# **Christmas Creek Expansion Public Environmental Review – Response to Public Submissions**

**Christmas Creek**

**25 September 2015  
CC-RP-EN-0120**

Figure 12 – Indirect Impact to GDE – Worst Case Dewatering Scenario

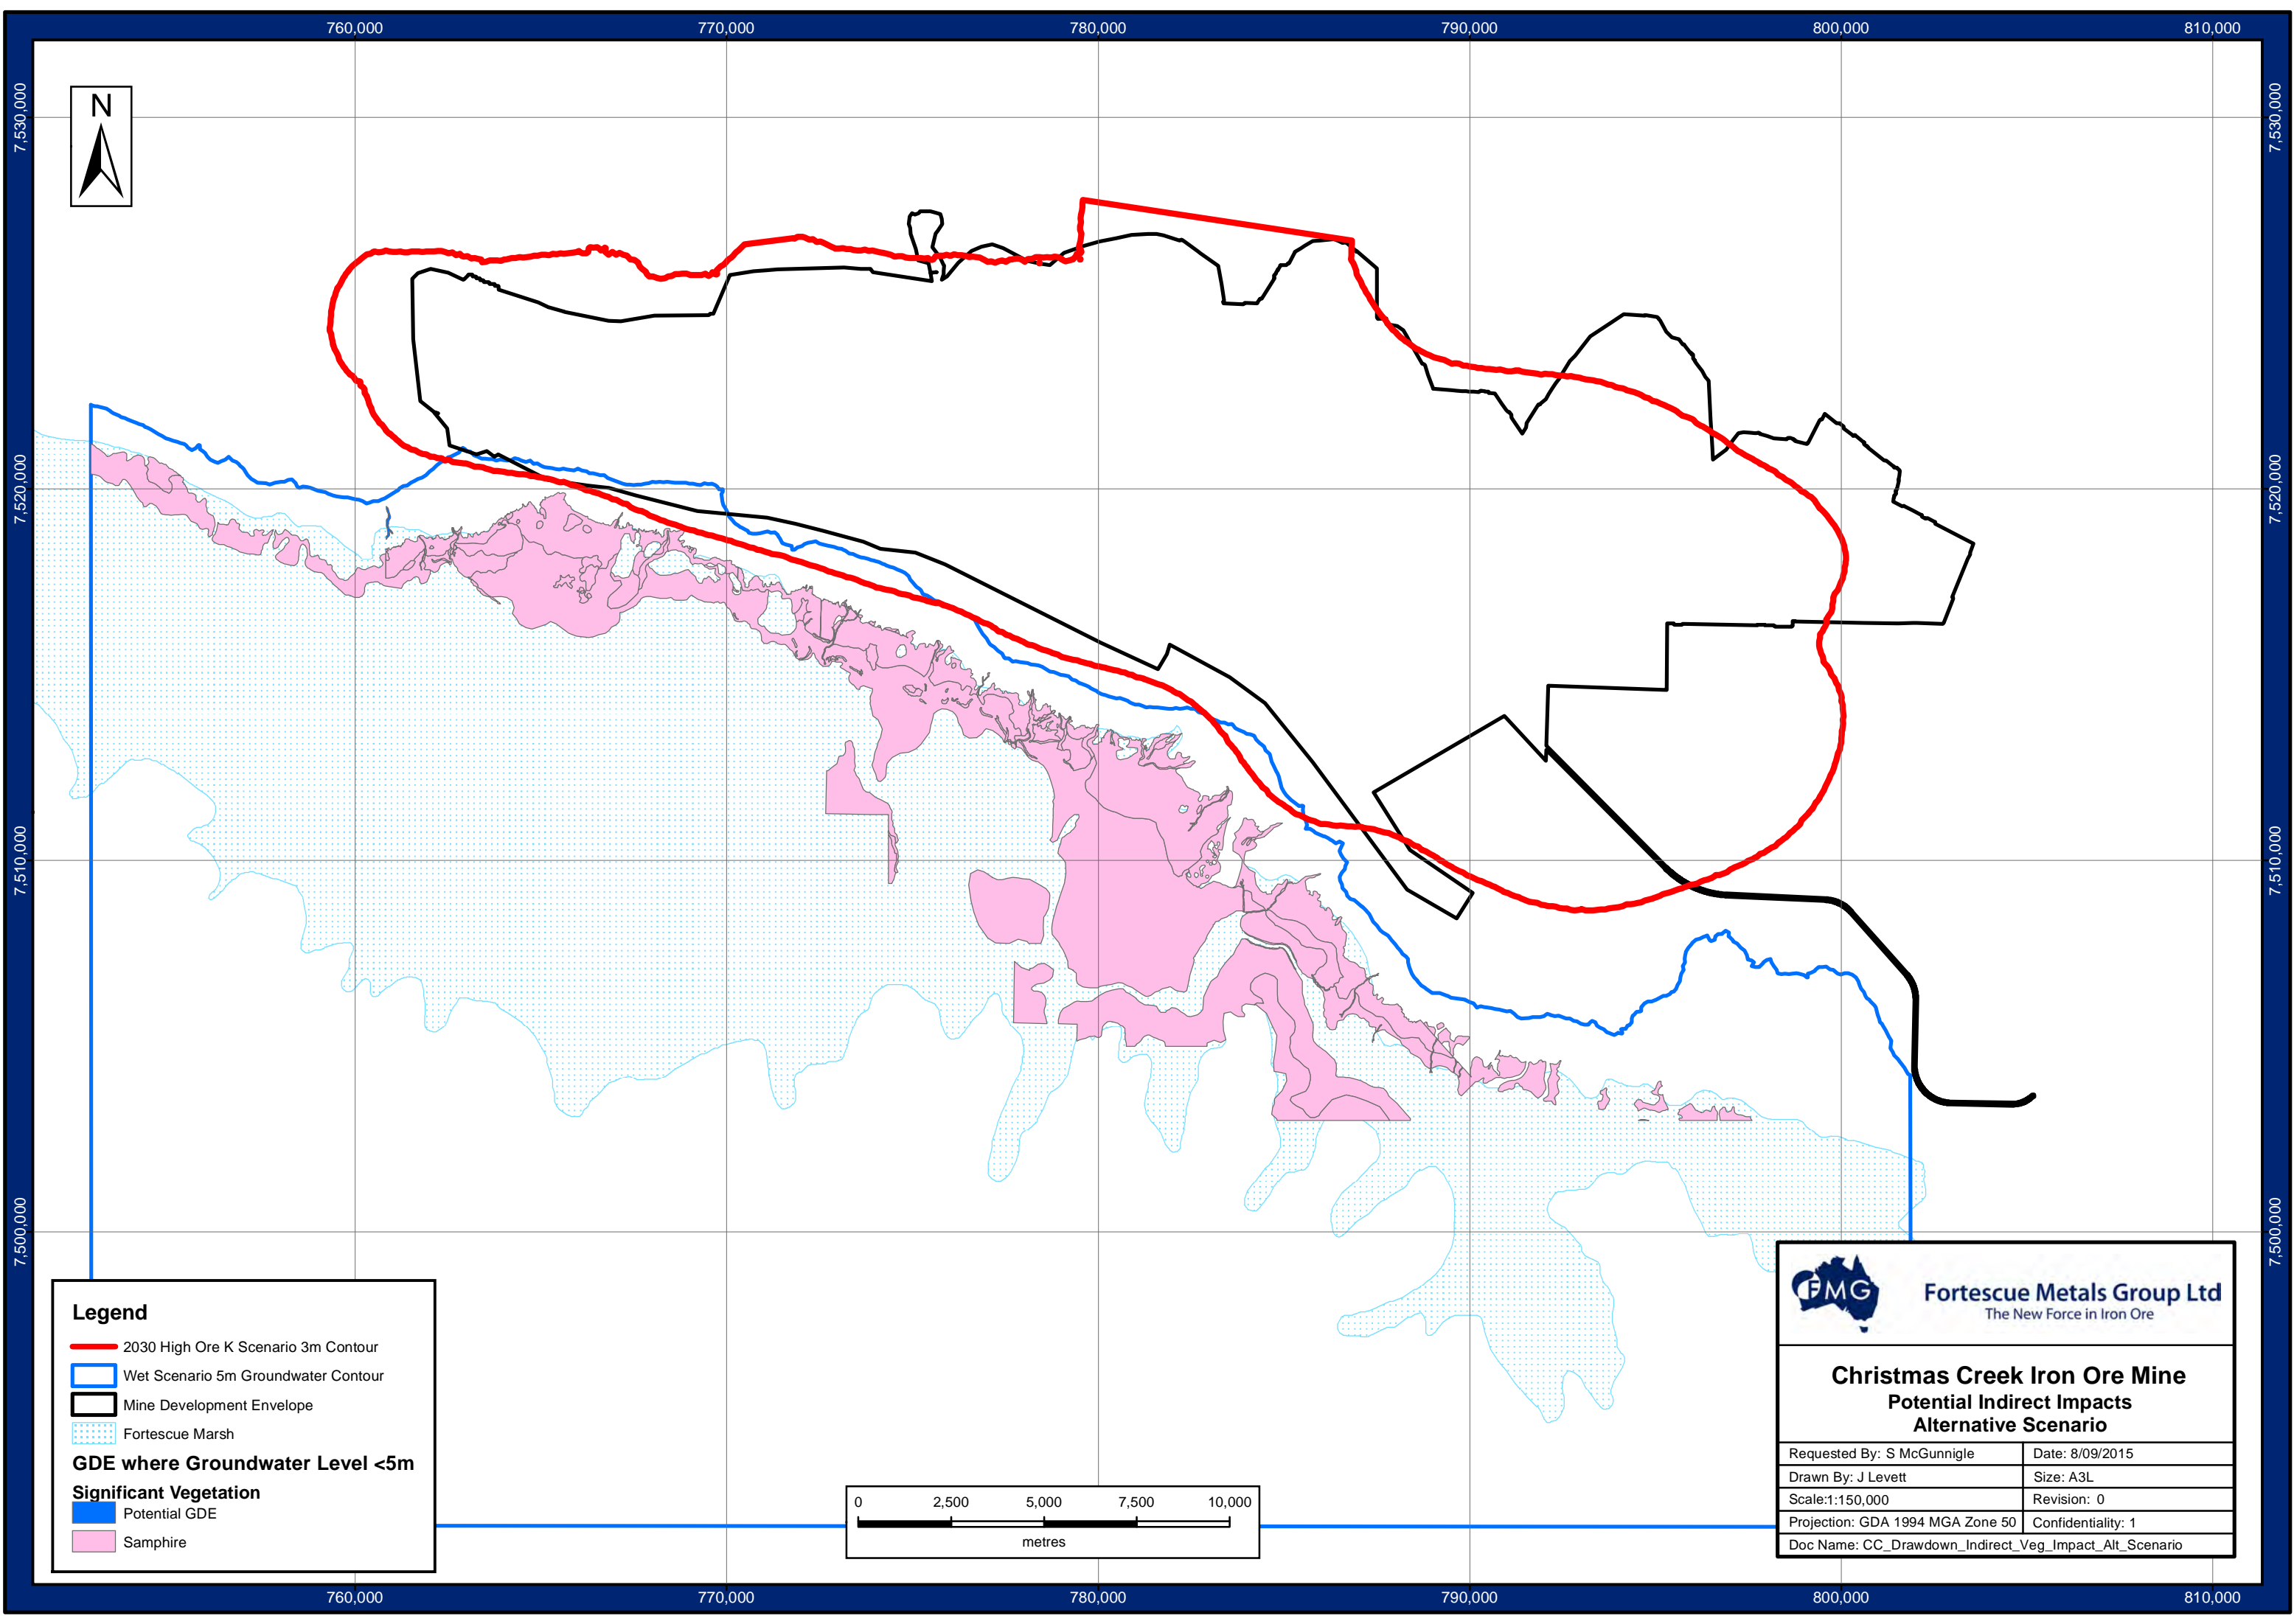
Item	Submitter	Submission and/or issue	Response to comment
3.10		<p>Groundwater dependent vegetation</p> <p>FMG are proposing an average annual dewatering volume of 40.5 GL/a and reinjection of 30.8 GL/a. The modelled drawdown of the Christmas Creek Expansion is predicted to lower the groundwater levels of RHIO tenement M46/519 (figures 21 to 28). The potential environmental impact is a decline in health of groundwater dependent vegetation (GDV) - RHIO is required under condition 6 of MS 824 and 826 to monitor vegetation health across its mine site in association with groundwater drawdown associated with mining and dewatering activities within mining tenements M46/518 and M46/519.</p> <p>The modelled drawdown from the Christmas Creek Expansion dewatering activities are predicted to lower groundwater levels of tenement M46/519 and in the areas of potential ground water dependent vegetation.</p> <p>The additional drawdown and duration of the drawdown of groundwater in the vicinity RHIO tenure may result in the decline in health of the vegetation within the RHIO tenements not associated with RH activities.</p>	<p>Fortescue agrees that groundwater drawdown associated with the Proposal will impact groundwater levels within neighbouring mining tenements. Section 7.7.2 of the PER addresses the overlap in mine dewatering areas of impact between Christmas Creek and RHIO. Figure 37 illustrates the overlapping groundwater drawdown contours and details that dewatering associated with RHIO proposal will impact areas with Fortescue's tenements.</p> <p>As stated in Section 9.7.2 of the PER "Areas where depth to groundwater is less than 5 m without mining occurring and drawdown of greater than 2 m is expected have been mapped on an annual basis and are presented in Figure 47 (2014) to Figure 61 (2028) to determine areas of indirect impact to GDE vegetation (VT01). A small area of VT01 in the southern part of the Survey Area is expected to be affected. This impact commences in 2026 and is expected to continue until 2028. Figure 62 shows the extent of indirect impact areas to VT01 for all years combined. The area of indirect impact to VT01 is 1.1 ha at its largest predicted extent".</p> <p>The area of impact depicted in the PER is located on the southern boundary of the Proposal. The closest area of potential impact to the RHIO tenement is approximately 5 km.</p> <p>Fortescue has also committed to the ongoing implementation of the <i>Vegetation Health Monitoring and Management Plan</i> (CC-PL-EN-0004) to identify and manage any potential indirect impacts to vegetation associated with the implementation of the Proposal.</p> <p>Fortescue has committed to the ongoing implementation of the Stakeholder Consultation ReInjection Management Plan, (CC-PL-EN-0006, PER Appendix 2A). Fortescue proposes Fortescue and RHIO continue consultation on groundwater management through the Chichester Joint Water Management Group.</p>

Figure 13 – 2015 Modelled Groundwater level (mAHD)

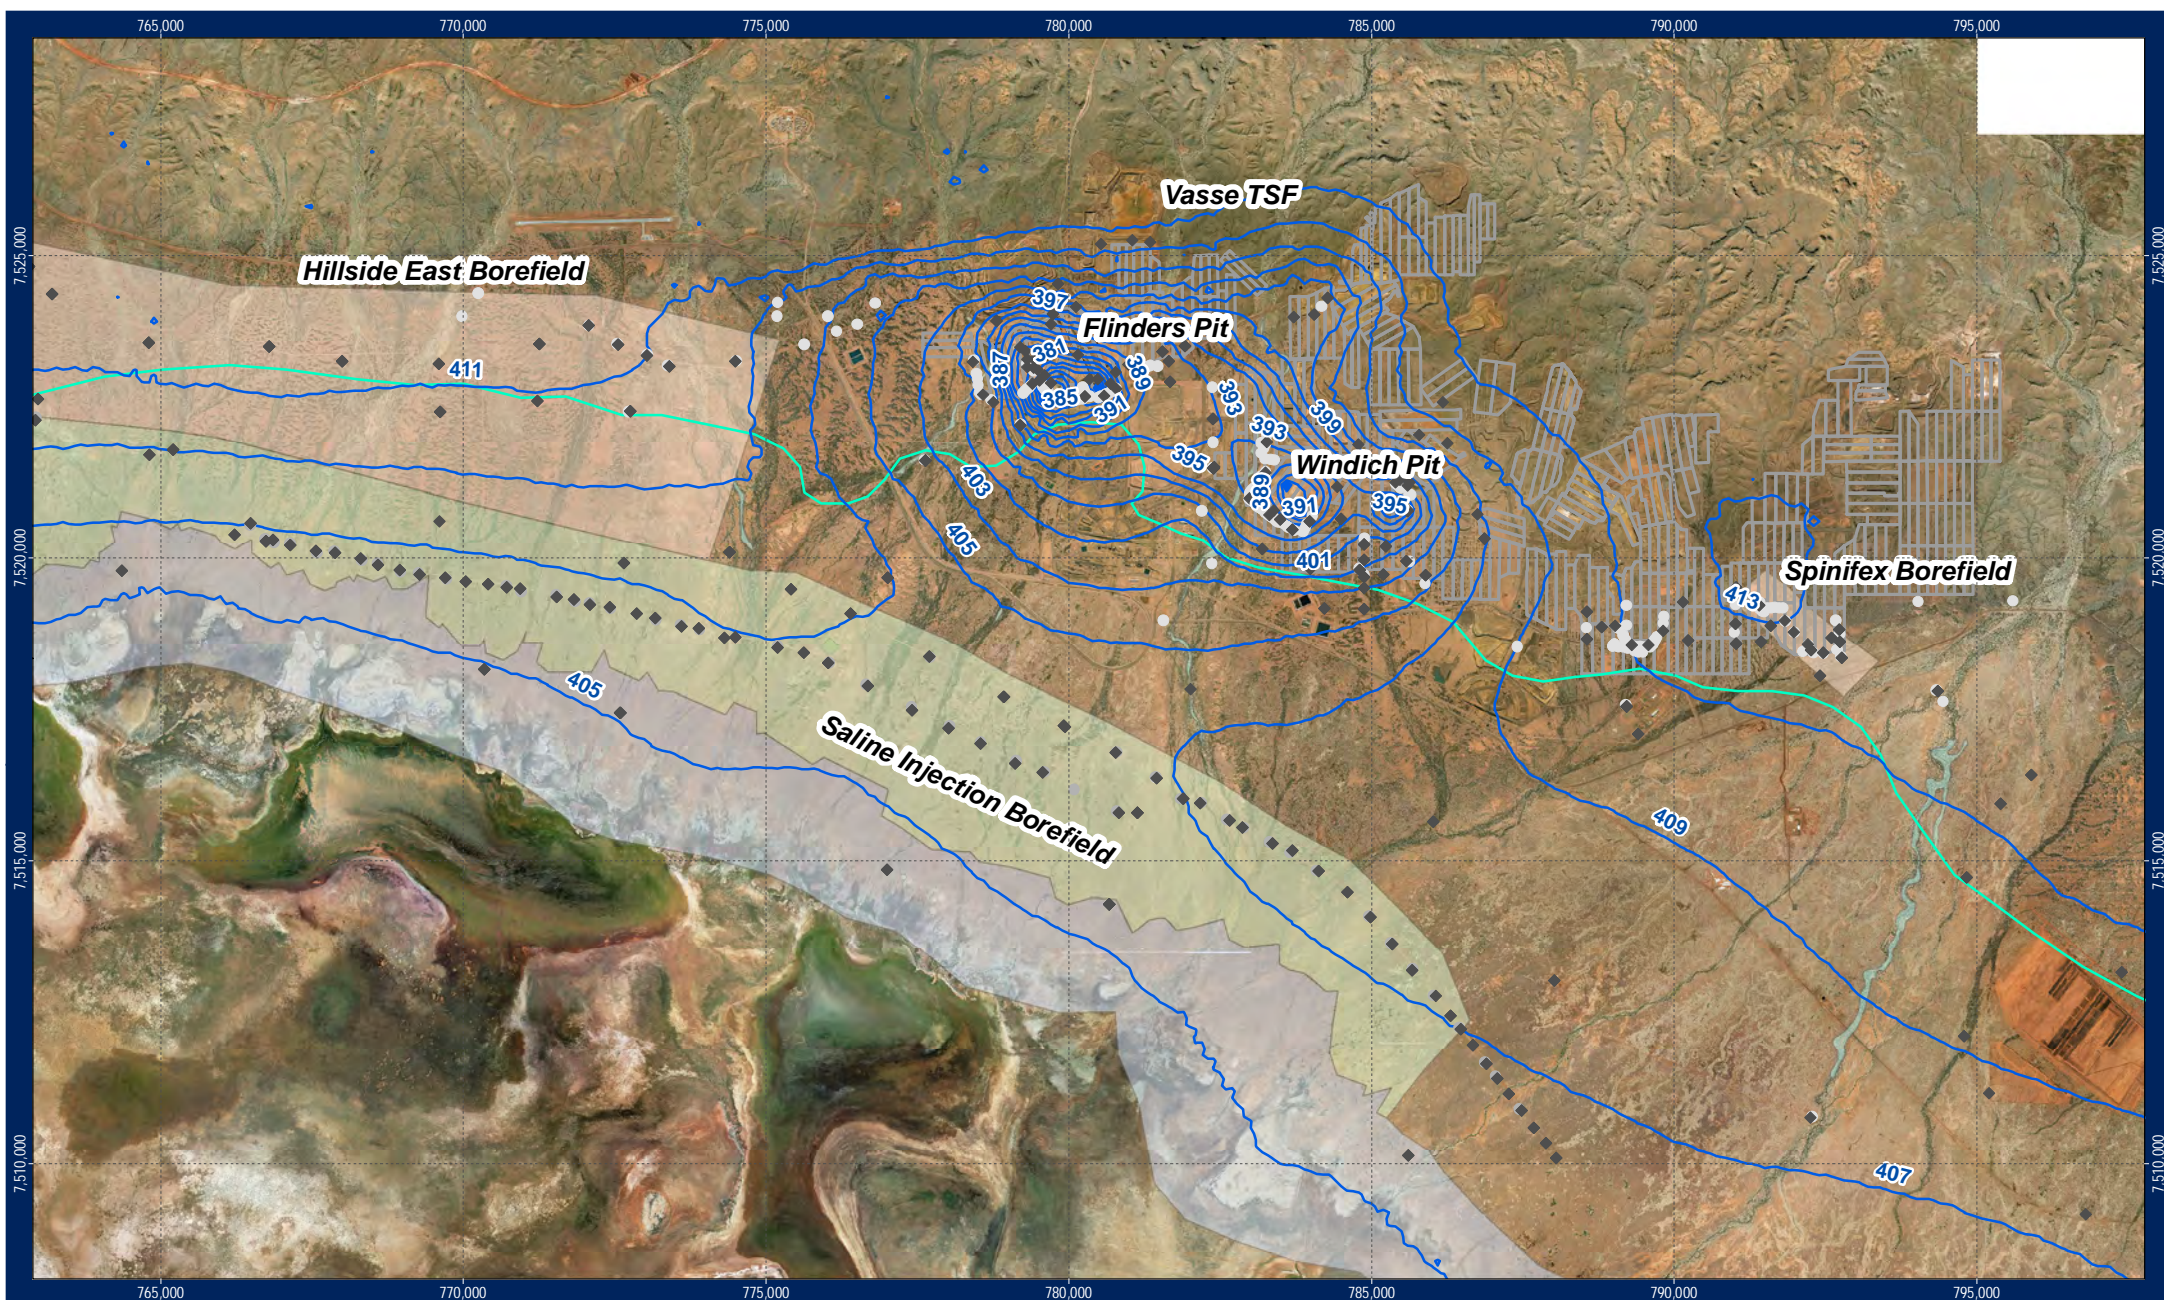
Item	Submitter	Submission and/or issue	Response to comment																																																												
3.1	Department of Water (DoW)	<p>Groundwater</p> <p>The groundwater modelling uses average predicted dewatering and injection volumes over the period 2014 to 2028 of 30.4 GL/a (no injection) and 40.5 GL/a (with injection) - with a peak annualised dewatering demand of 73.5 GL/a (with injection) in the year ending June 2015. It is unclear if FMG intend to adhere to the dewatering amounts used in the modelling or increase dewatering to 110 GL/a. It is also unclear what the dewatering and mounding response would be to a sustained 110 GL/a dewatering and injection scenario (with use of up to 35 GL/a).</p> <p>FMG should provide clarification on their intended dewatering and injection regime over the Life of Mine. In addition, FMG should clarify what dewatering sand mounding response is anticipated, should the dewatering and injection regime vary considerably to the dewatering volumes used in the modelling. This information should be provided for assessment, before the DoW can confirm potential impacts have been adequately assessed.</p> <p>DoW will review the Christmas Creek (and Cloudbreak) Groundwater operating strategy (GWOS) to ensure that the bores proposed to be used to monitor water quality to monitor for possible acid metalliferous drainage are suitable and included in the strategy / strategies.</p>	<p>The hydrological modelling presented in the Christmas Creek Iron ore Mine Expansion Public Environmental Review (PER) was undertaken during 2013, resulting in the first year of the model being 2014. The basis of the model was that the expansion mine plan and dewatering would commence simultaneously resulting in the initial peak water abstraction presented in Table 17 of the PER. However the peak water abstraction is now forecast to occur in 2017, with the same trend as to that presented in the PER albeit delayed by two years (Chart 1).</p> <p><b>Chart 1: Revised modelled annual water abstraction hydrograph.</b></p>

Item	Submitter	Submission and/or issue	Response to comment
			<p>represent a realistic assessment of the proposal.</p> <p>No simulation presented includes for a water demand of 35GL/a as this is not representative of operations. In each sensitivity assessment the mine water use presented in Table 23 (of PER Appendix 5A) has been used for modelling. All excess water has been injected to provide a realistic simulation. Peak water use is simulated to be 12 GL/a, based on ore processing plant design criteria.</p> <p>Fortescue's predicted dewatering and injection regime is provided in Table 23 (of PER Appendix 5A) (base case scenario). Likely variation due to climatic and parameter variation is also presented in terms of abstraction/injection change and impacts. Whilst mine planning and production sequencing alterations cannot be discounted over a twenty four year period of time any changes are likely to result in only minor variations to the yearly volumes in comparison to the sensitivity analysis presented. Quarterly and annual mine plans are assessed from a groundwater perspective and impacts to key receptors and compliance to approval obligations assessed. Comparison and deviation from Life of Mine (LoM) simulated abstraction/injection regimes are compared and discussed as part of the triennial aquifer review process.</p> <p>Groundwater Operating Strategies (GWOS) are designed to address the requirements of approvals sought under the <i>Rights in Water and Irrigation Act 1914</i>. The GWOS is not intended to be used to document and manage the risks associated with other groundwater aspects such as Acid and/or Metalliferous Drainage (AMD), tailings disposal, bulk fuel storage or landfill monitoring. Fortescue has committed to implementing the <i>Acid and/or Metalliferous Drainage Management Plan</i> (100-PL-EN-1016, PER Appendix 2F) and undertaking the <i>Acid and Metalliferous Drainage Sampling Plan</i> 100-PL-EN-1014 at Christmas Creek to assess and manage any potential AMD. Monitoring the impacts to groundwater associated with discharges of waste will be managed under the provisions of Part V of the <i>Environmental Protection Act 1986</i> administered by the Department of Environment Regulation (DER).</p>
